Arlberg Ski Club Limited
Charlotte Pass NSW
PO Box 645
Annerley QLD 4103
Attention: Peter Brooks

Project 215619.00
15 September 2022
R.001.Rev0
MJJ

Preliminary Geotechnical Assessment
Proposed Additions
Arlberg Ski Lodge, Charlotte Pass Village

Sk2a

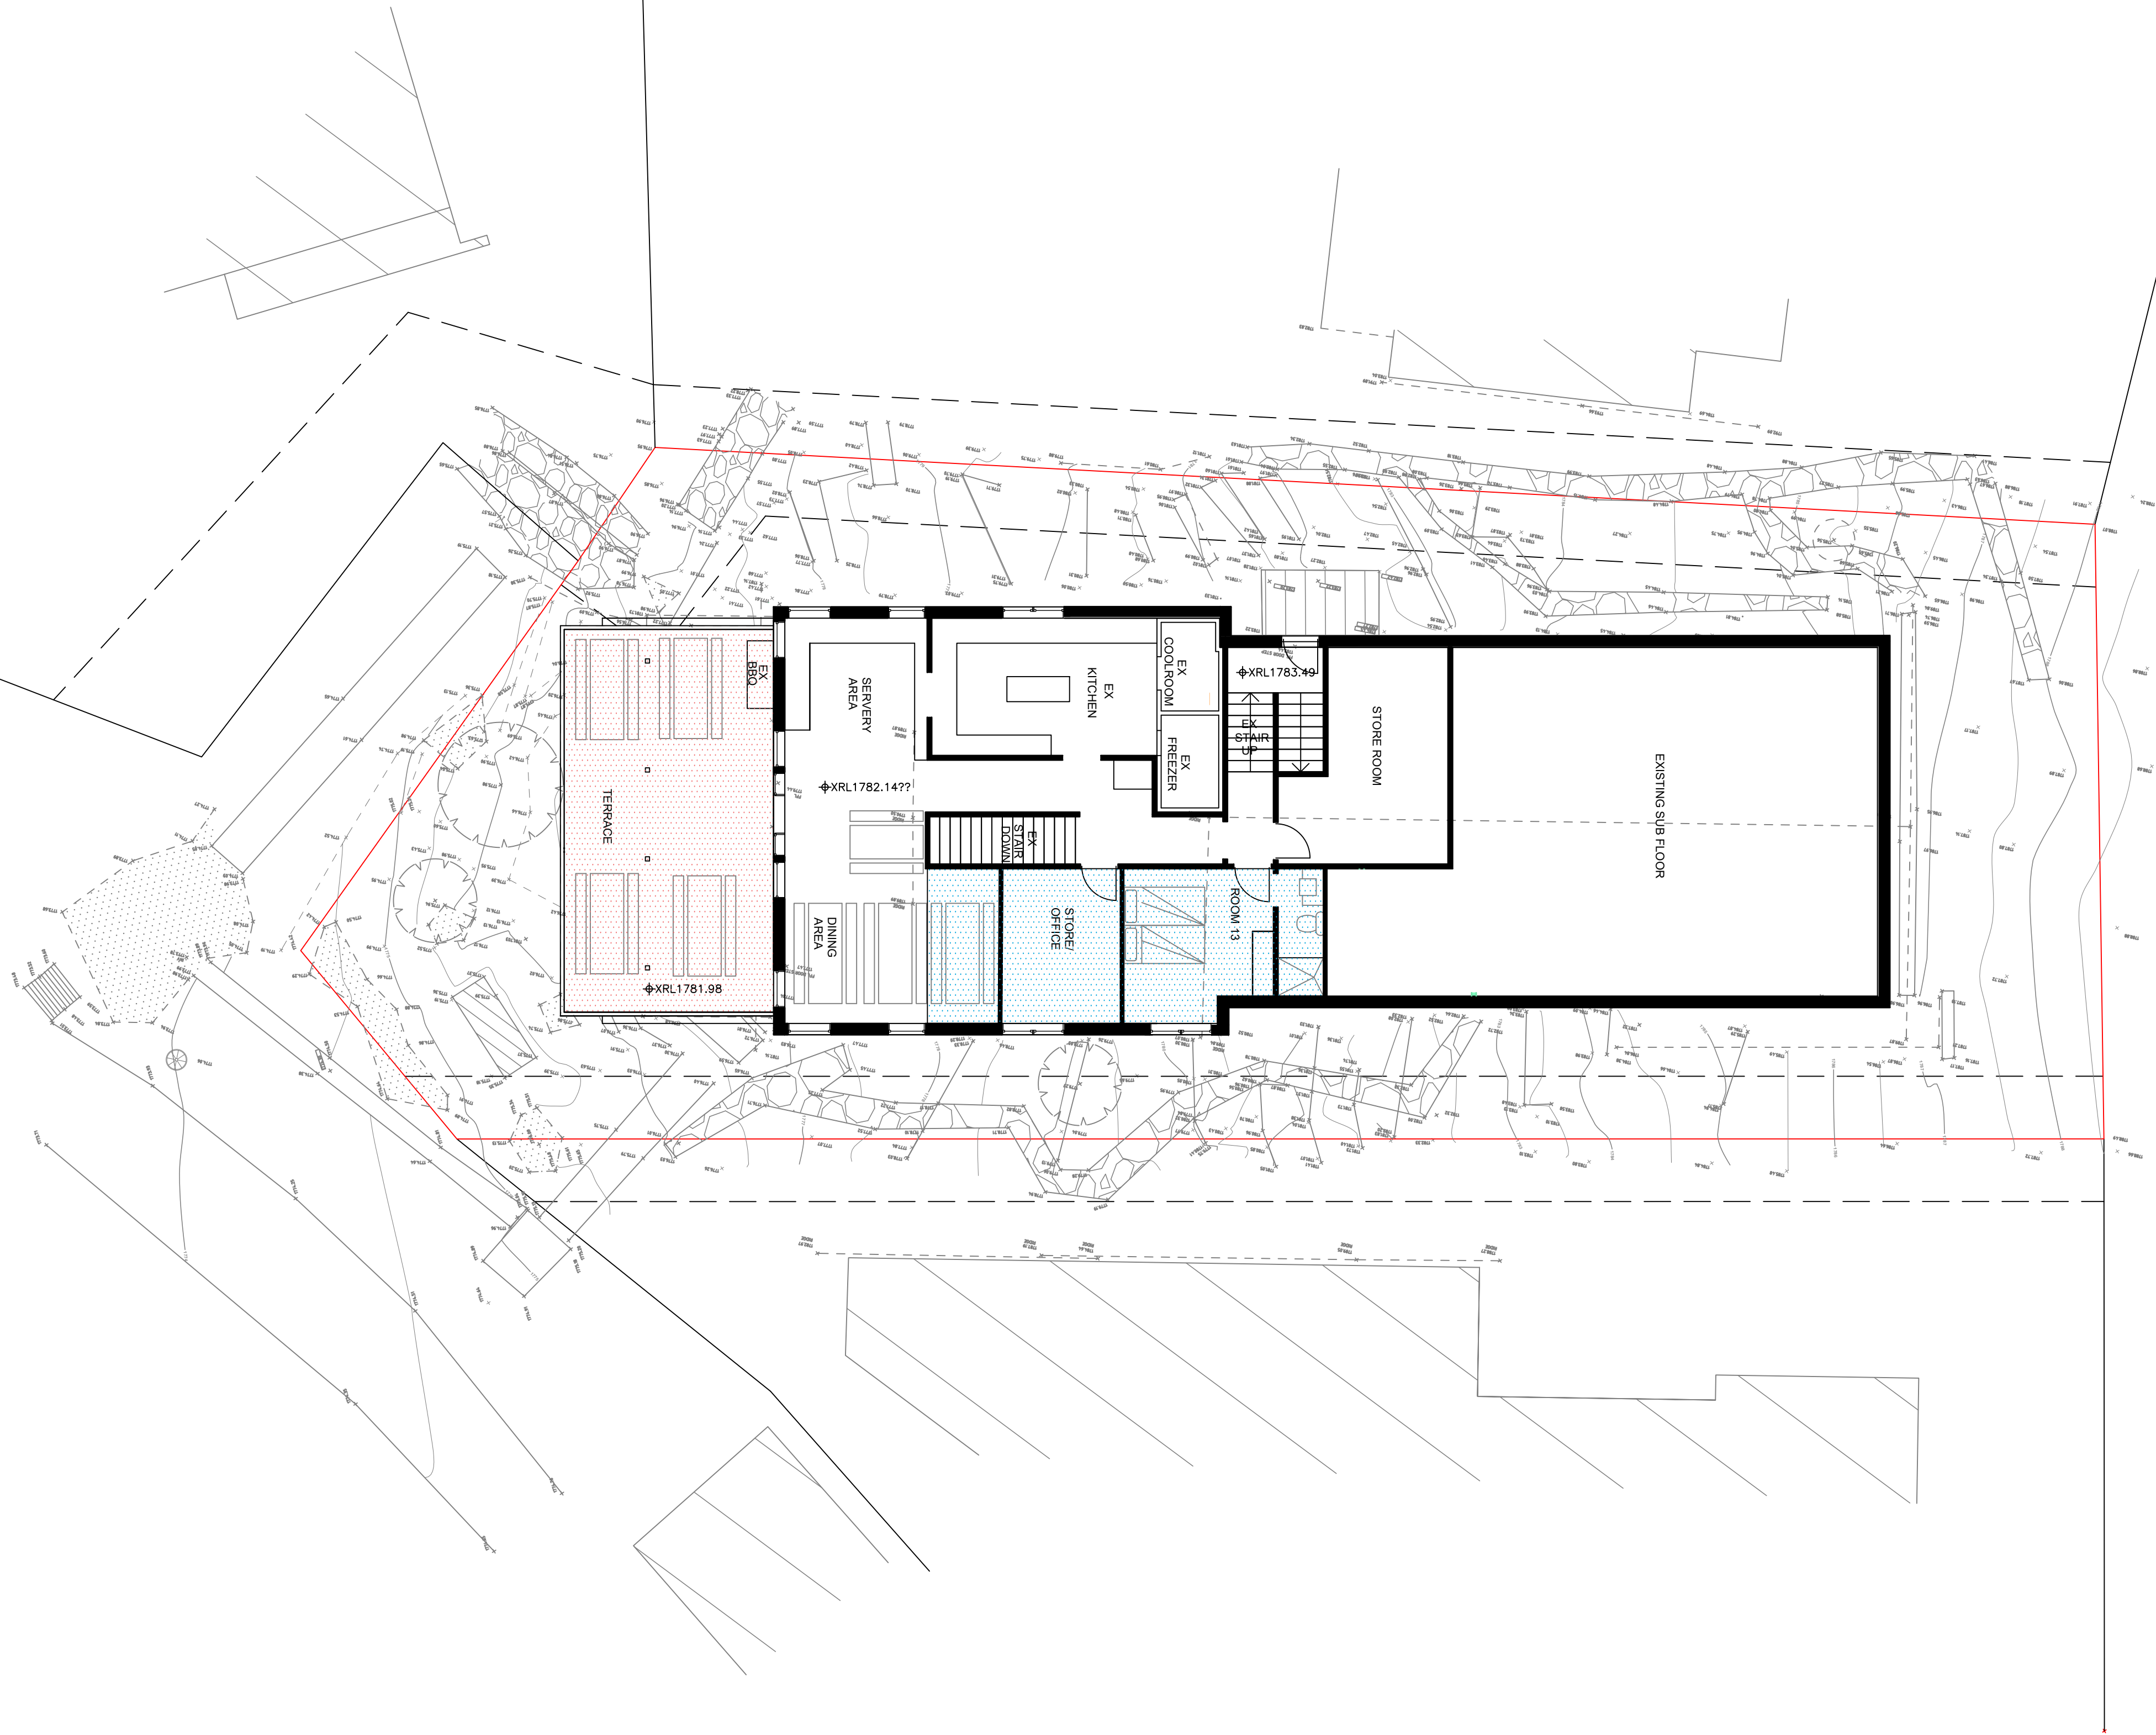
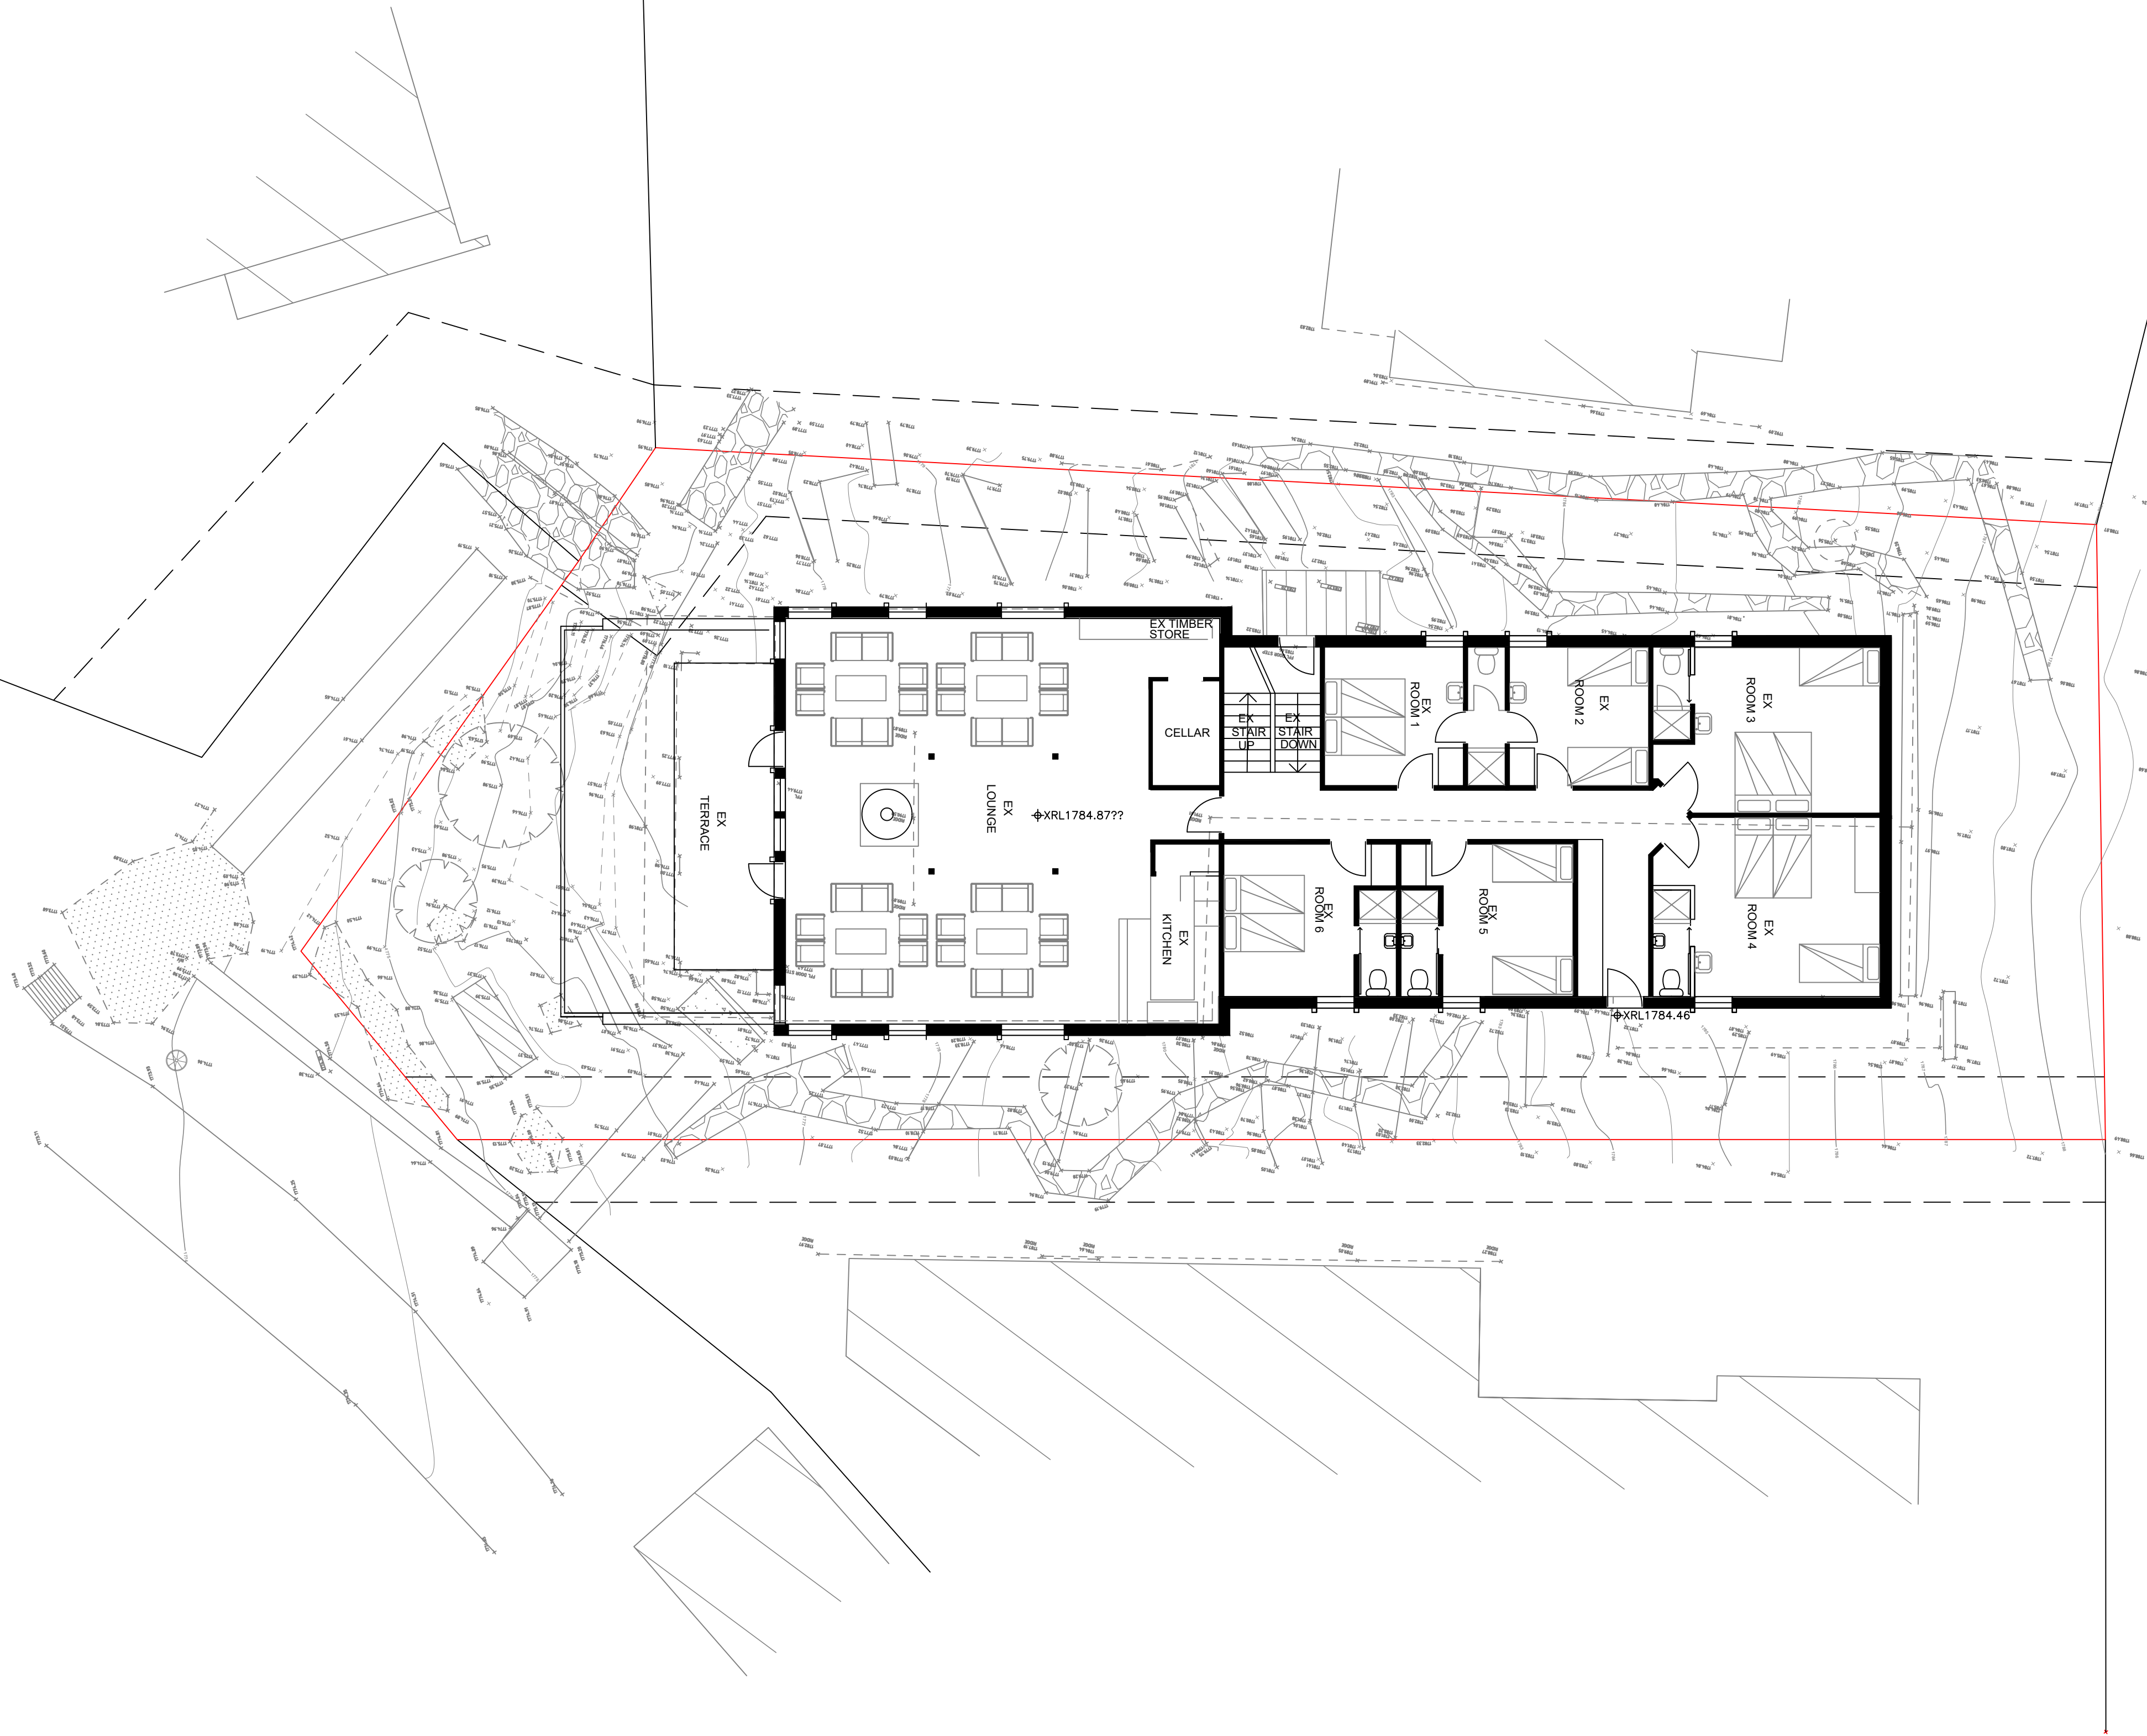
Site works as detailed in Drawings SK1a – SK7a dated 1 January 2021 (see attached drawings) indicate that a maximum depth of cut of 0.7 m and a maximum depth of fill of 0.9 m will be required to facilitate construction levels.

- All loads from the new structure including the lower ground floor slab are to be transferred through the overburden soils (possibly prone to soil creep) to within the weathered rock. A minimum socket of 0.5 m into weathered rock (minimum extremely low strength) is recommended with an allowable end bearing pressure of 300 kPa.
- All new footings must be founded below the zone of influence of any adjacent/existing footings or backfill trenches from buried services or underground storage tanks.
- Where required, fill must be compacted to at least 95% standard dry density ratio within 2 percentage points of optimum moisture content.

- The edges of any site excavation and/or fill required to establish the lower floor area must be supported by engineer designed retaining walls.
- All footing excavations must be viewed by a Geotechnical Engineer to confirm suitability of the founding stratum.
- Site surface drainage or and existing subsurface drainage systems must not be compromised by the proposed works.
- All stormwater and/or sewage that is generated by the new development must be disposed offsite in a controlled manner such that it does not impact the performance of the structure and/or surrounding ground.
